[Docket No. FAA-2009-1088; Directorate Identifier 2008-SW-76-AD; Amendment 39-17872; AD 2014-12-11]

#### Airworthiness Directives; Sikorsky Aircraft Corporation Helicopters

**ACTION:** Final rule.

**2014-12-11 Sikorsky Aircraft Corporation:**  
Amendment 39-17872; Docket No. FAA-2009-1088; Directorate Identifier 2008-SW-76-AD.

**Figure 1-2A – Maximum Gross Weight for HEC Requiring Cat ‘A’**

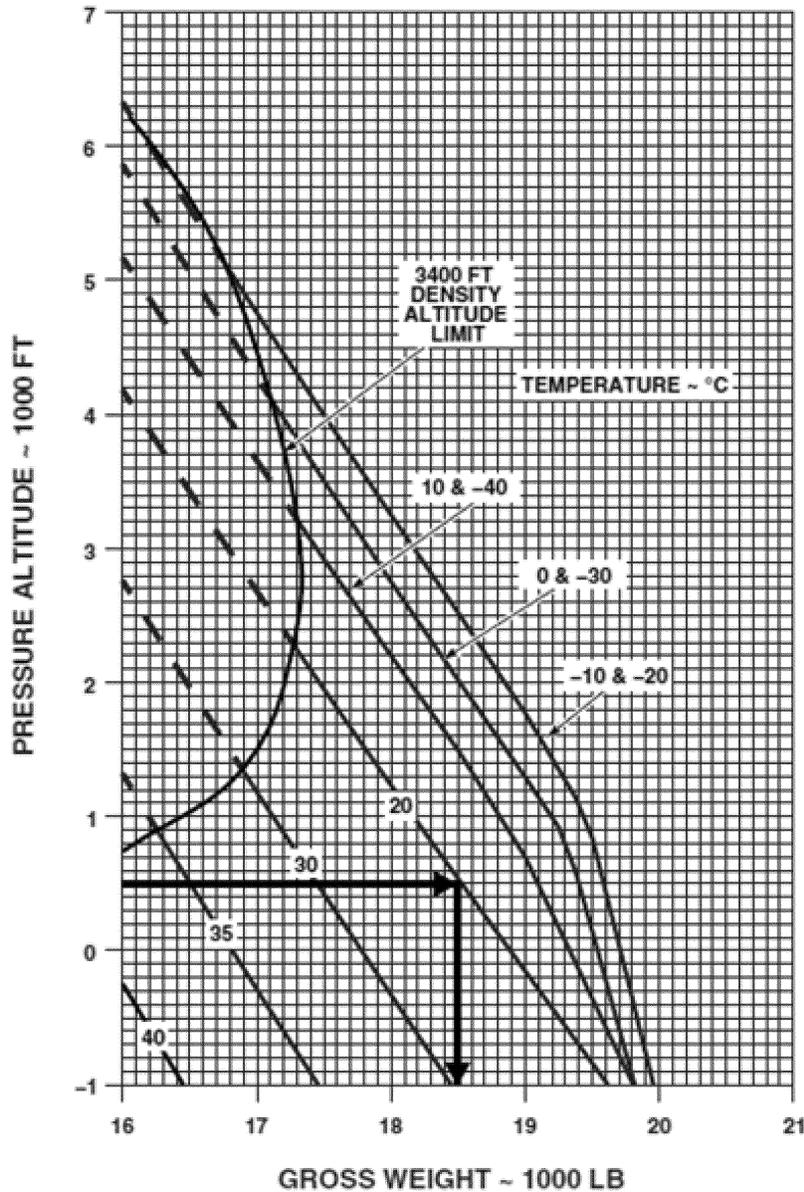
(iii) Add the following and insert Figure 1 to Paragraph (e)(3)(iii) of this AD: "HOIST" Maximum gross weight for Human External Cargo, which requires category 'A' performance capabilities, is limited to the gross weight determined in accordance with the following Figure 1 to Paragraph (e)(3)(iii) of this AD for your altitude and temperature with the air-conditioner, anti-ice, and bleed air turned off.

**Note 1 to paragraph (e)(3)(iii) of this AD:** Figure 1 to Paragraph (e)(3)(iii) of this AD becomes Figure 1-2A when inserted in the "Weight Limits" section of your RFM.
